Access Compliance Report

Public Rights-of-Way

(Pedestrian Signals)

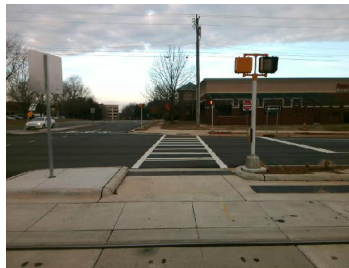
PROW/ADA: TMUTCD 4e.08, R404.7.3, R404.7.2, R209.1, MUTCD 4e.10

N/A	B 1 Clear Xing Direction?	Yes	N/A	B 2 Clear Xing Direction?	N/A
	B 1 Crossing Direction	To W		B 2 Crossing Direction	N/A
Yes	B 1 DistanceTo XWalk (in)	0.0	N/A	B 2 DistanceTo XWalk (in)	N/A
No	B 1 DistanceTo Curb (in)	14.0	N/A	B 2 DistanceTo Curb (in)	N/A
Yes	B 1 Diameter (in)	2.0	N/A	B 2 Diameter (in)	N/A

Possible Solutions: Replace Signal Push Button With APS Button on New Post. Remove & Relocate Sign.
